## The Redevelopment of Union Pier

Union Pier is a 70-acre waterfront site in Charleston's downtown historic district. Since the 1700s, the site has been used for shipping and port operations, and more recently a cruise terminal. It is currently owned by the South Carolina Ports Authority (SCPA).

A  
Union Pier

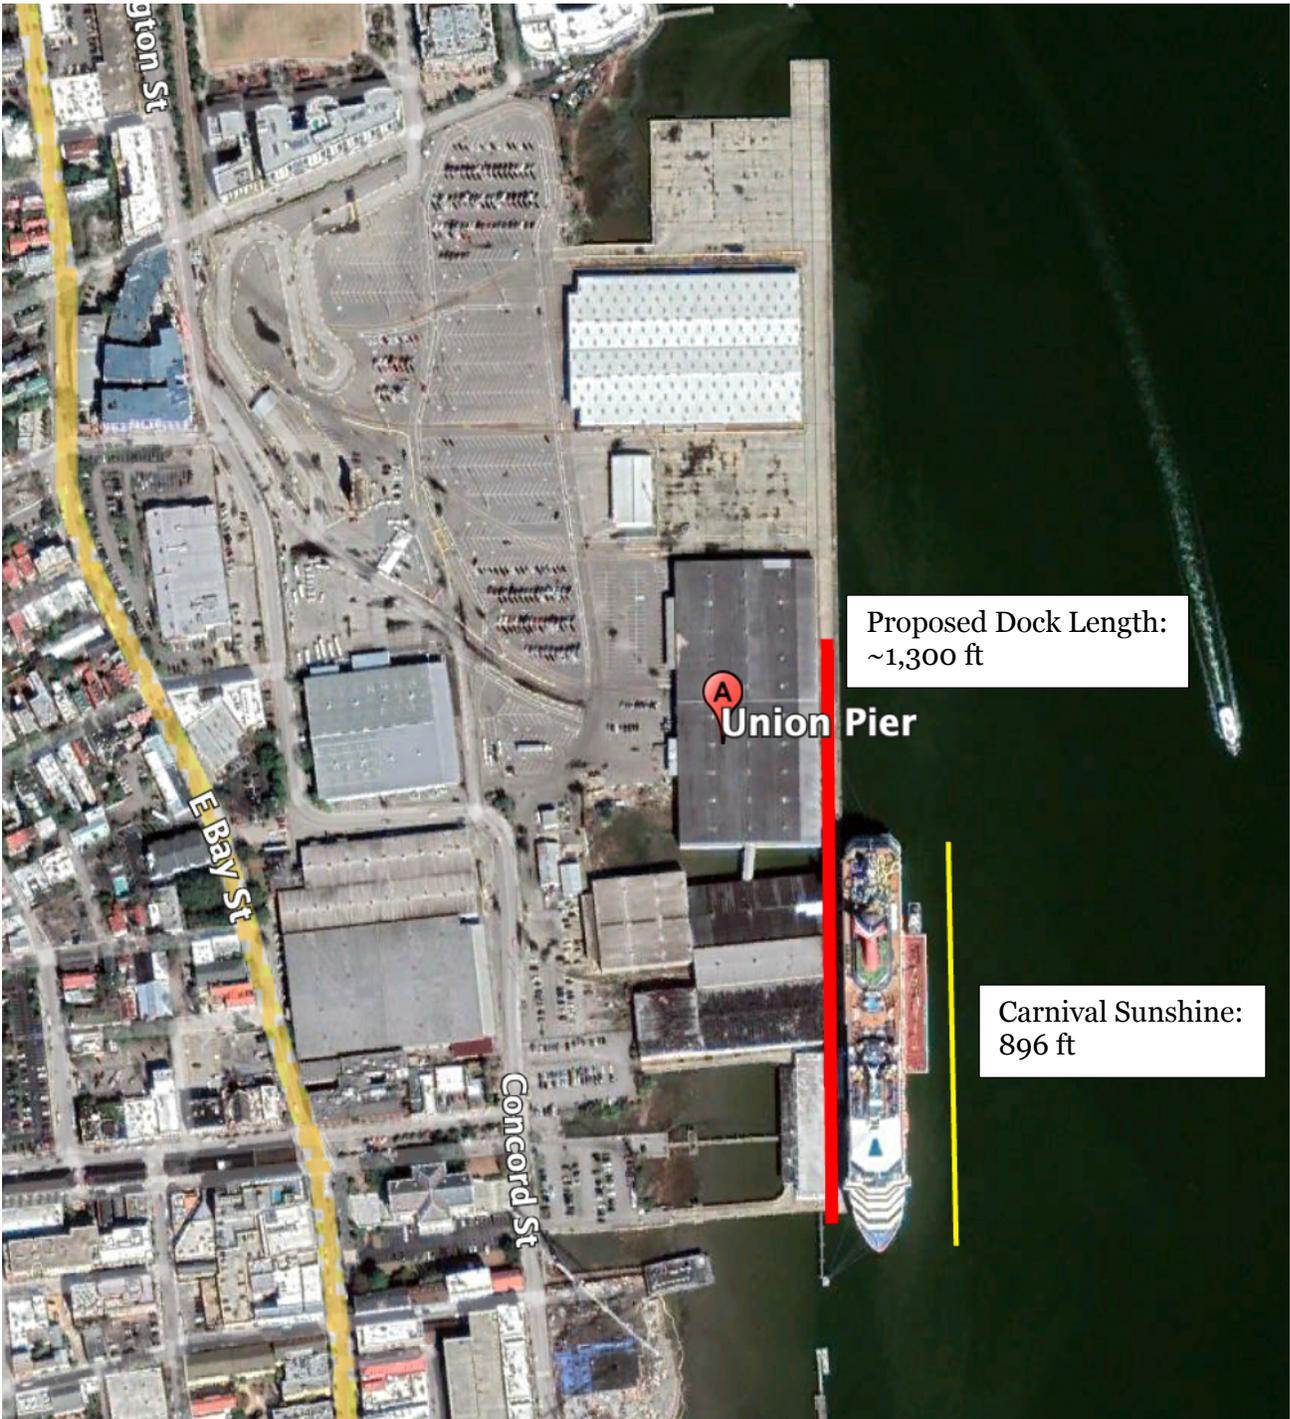
- The voluntary cruise management plan between Charleston and the SCPA limits cruise operations to no more than 104 ships per year, hosting only one ship at a time, and no larger than a 3,500-passenger capacity. **The proposed dock length is excessive and should be reduced to no more than 900 feet to ensure the SCPA's voluntary commitment is never violated or increased in the future.**

Proposed Dock Length:  
~1,300 ft

Carnival Sunshine:  
896 ft
